National Committee on Uniform Traffic Control Devices

Recommended Changes to Proposed Text for 11th Edition of the MUTCD

Docket Number: FHWA-2020-0001

- 1 Federal Register Item Number: 540-552
- 2 NPA MUTCD Section Number: Section 8B.01-8B.26
- 3 **Legend:** Base text shown in proposal is the NPA "clean" proposed text.
 - NCUTCD recommendation for text to be added in final rule.
 - NCUTCD recommendation for text to be deleted in final rule.
 - NCUTCD recommendation for text to be moved/relocated in final rule.
 - NPA text that was not previously approved by NCUTCD but is now approved.
 - Explanatory note: [Note that explains purpose of recommended change.]

Figure 8B-3. Crossbuck Assembly with a YIELD or STOP Sign on a Separate Sign Support

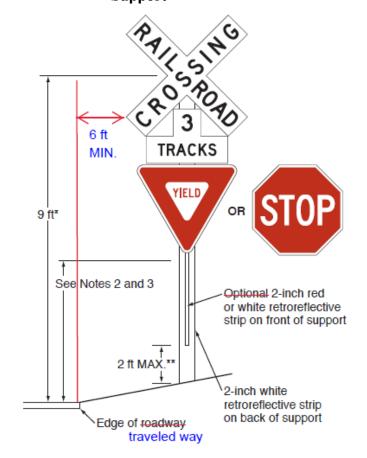
Section 8B.04 Comments: NCUTCD recommends changes to Guidance statements in 8B.04 to delete "engineering study" and add references to the Diagnostic Team because the Diagnostic Team should determine whether STOP or YIELD signs are appropriate at passive grade crossings and at T-intersections with inadequate clear storage distance. NCUTCD also recommends changes to the Standard statement to delete the requirement for a YIELD sign on the approach to a passive grade crossing at a highway-highway intersection controlled by a traffic signal because the Diagnostic Team should make the determination of the appropriate traffic control devices.
